**MINOR AMENDMENT TO SITE DEVELOPMENT PLAN
APPROVED PRIOR TO EFFECTIVE DATE OF IDO**

DESCRIPTION:
THIS MINOR AMENDMENT IS FOR THE CONSTRUCTION OF AN ADDITIONAL DRIVEWAY ENTRANCE INTO THE PROPERTY, RELOCATION OF THE PEDESTRIAN GATE AND SIDEWALK INTO THE PROPERTY, AND MINOR CHANGES TO THE LANDSCAPING TO ACCOMMODATE THE NEW DRIVEWAY.

DRB PROJECT NO. 1011638

L&C TRANSPORT OFFICE AND SHOP
112 94th Street NW, Albuquerque, New Mexico 87121

SITE PLAN

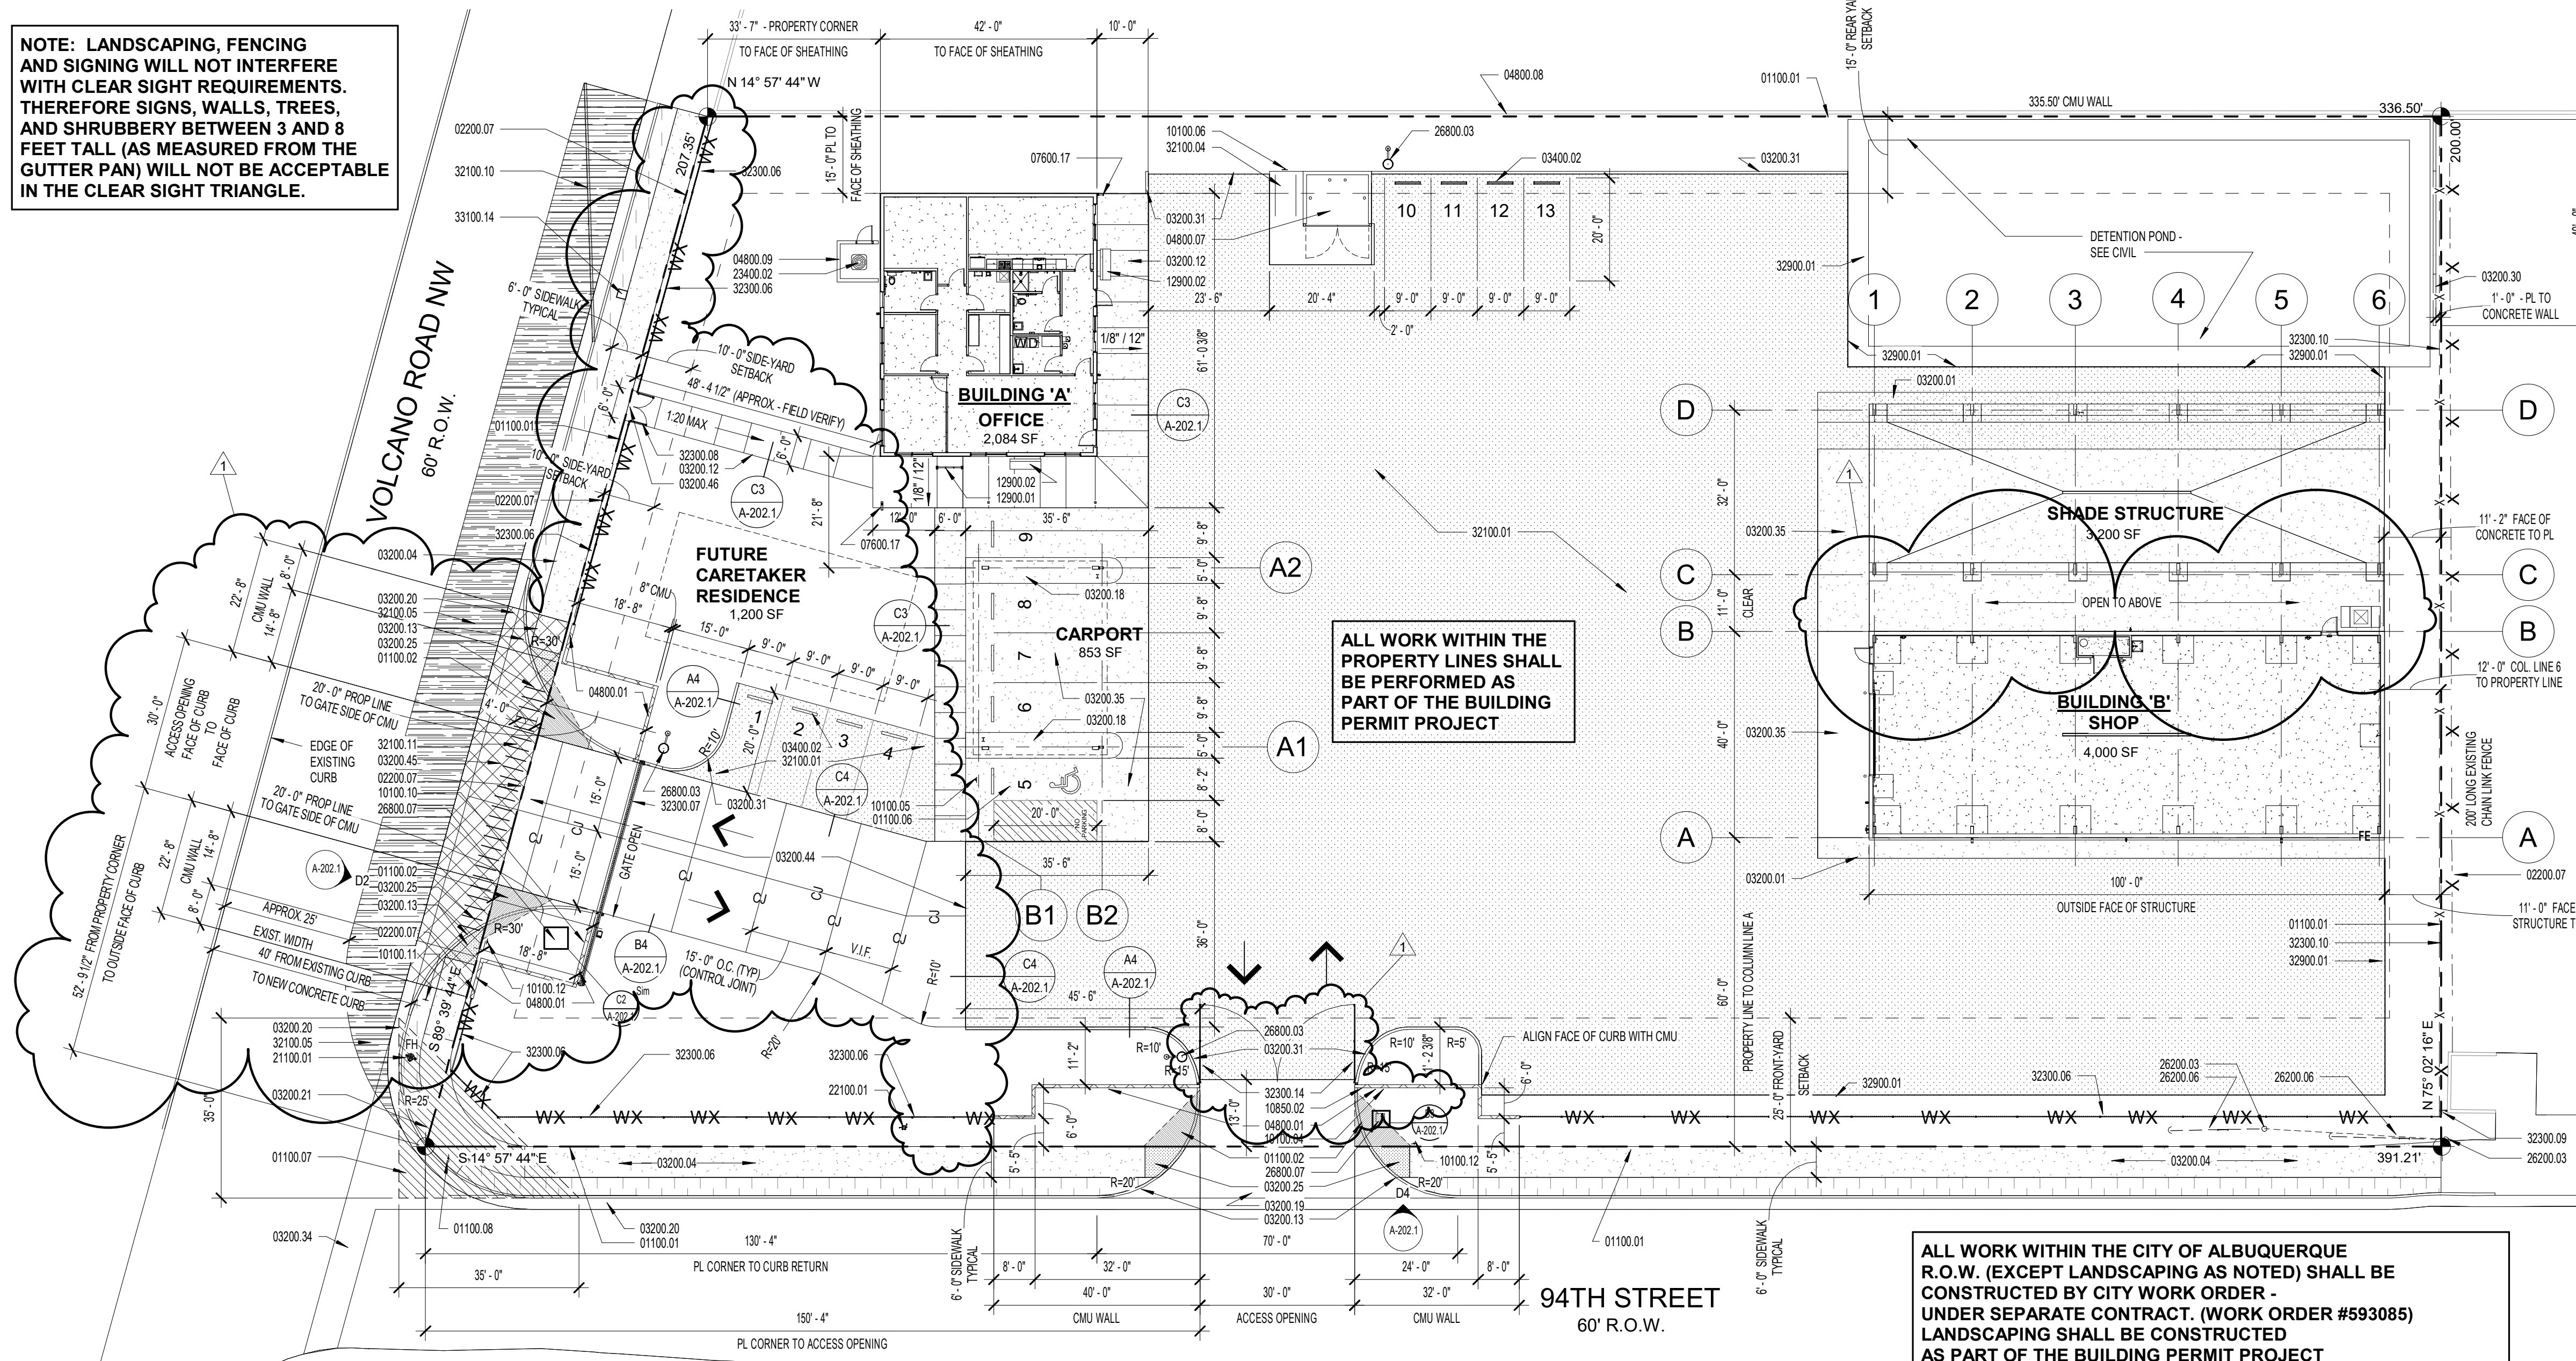
- AN ADDITIONAL DRIVEWAY / CURB CUT WILL BE INSTALLED ON VOLCANO RD. NW. AN AUTOMATIC SLIDING GATE SHALL BE INSTALLED AT THAT ENTRANCE. THE ENTRANCE GATE ON 94TH ST. WILL BE A MANUAL SWING DOUBLE GATE.
- PEDESTRIAN ACCESS AND GATE WILL BE FROM VOLCANO RD. NW.
- ALL FENCING ALONG VOLCANO AND 94TH ST. WILL BE BROUGHT IRON MASONRY WALLS WILL BE INSTALLED ON EACH SIDE OF THE VEHICLE GATES.
- FOUR INTERIOR PARKING SPACES WILL BE LOCATED NORTH OF THE HANDICAP PARKING SPACE.
- THE SHADE STRUCTURE IS A SEPARATE STRUCTURE FROM THE SHOP BUILDING PER THE APPROVED BUILDING PERMIT SET.

LANDSCAPING PLAN

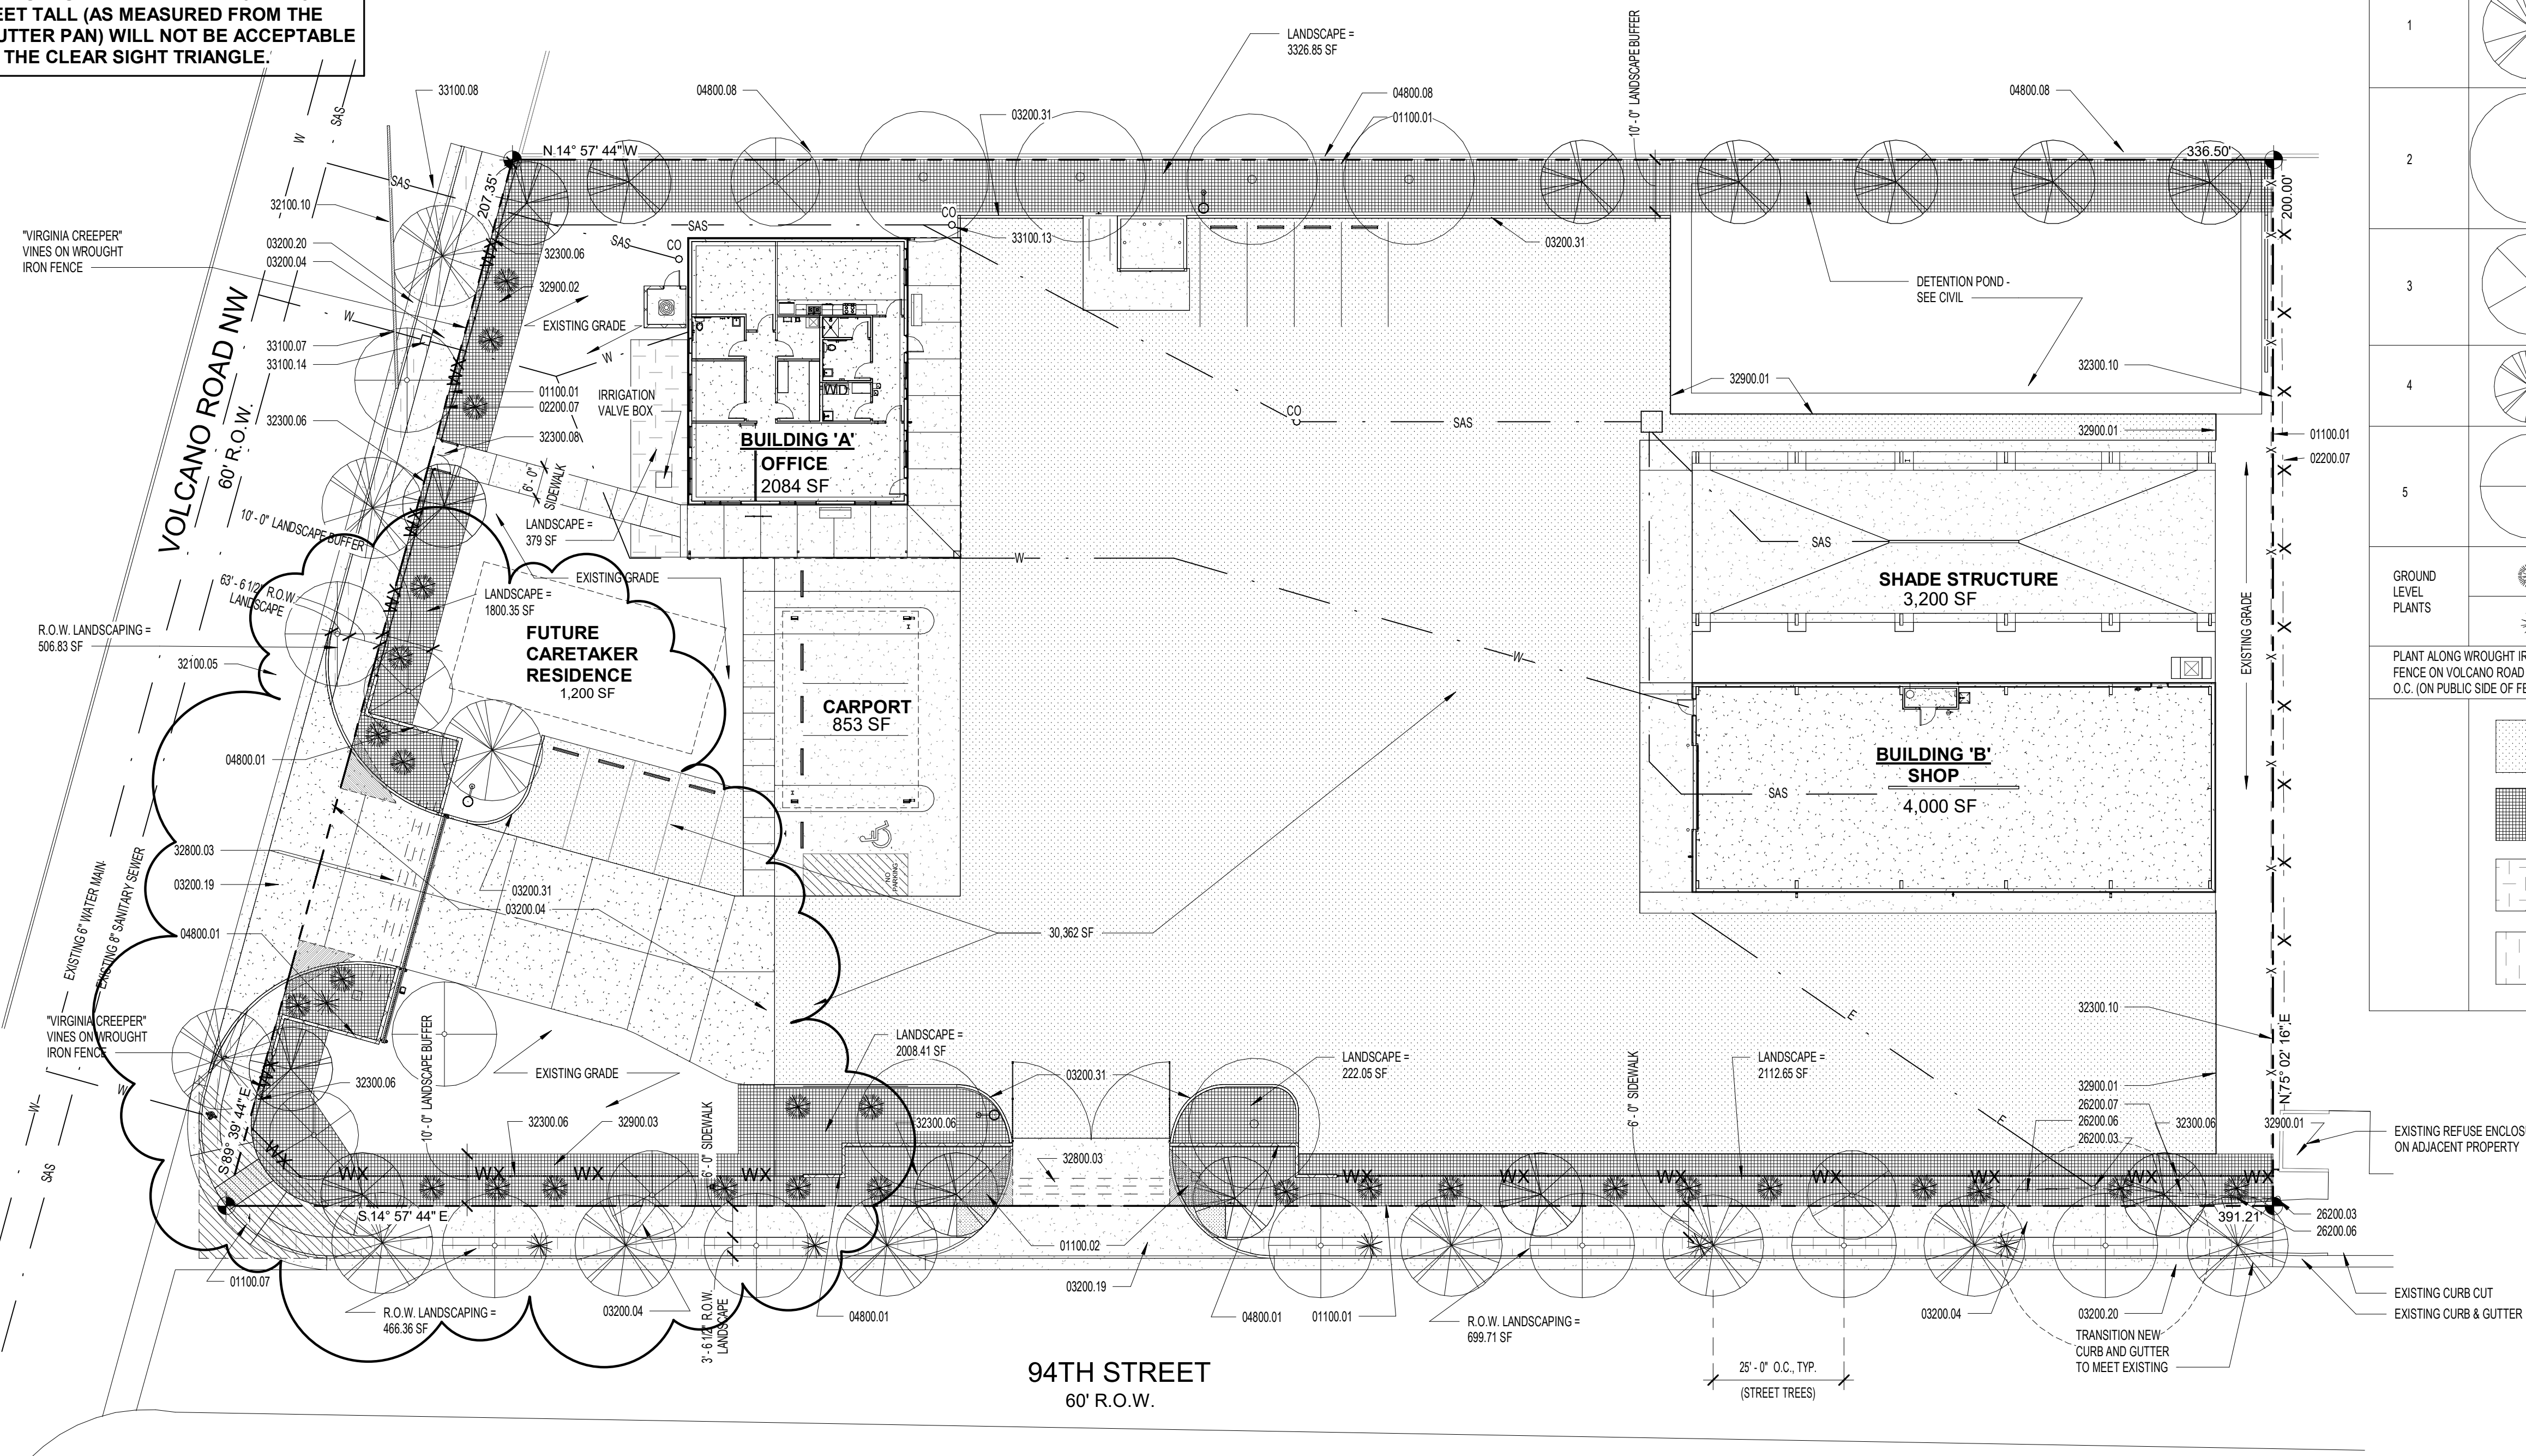
LANDSCAPE REQUIREMENTS PER MINOR AMENDMENT TO SITE PLAN / SITE PLAN AMENDMENT
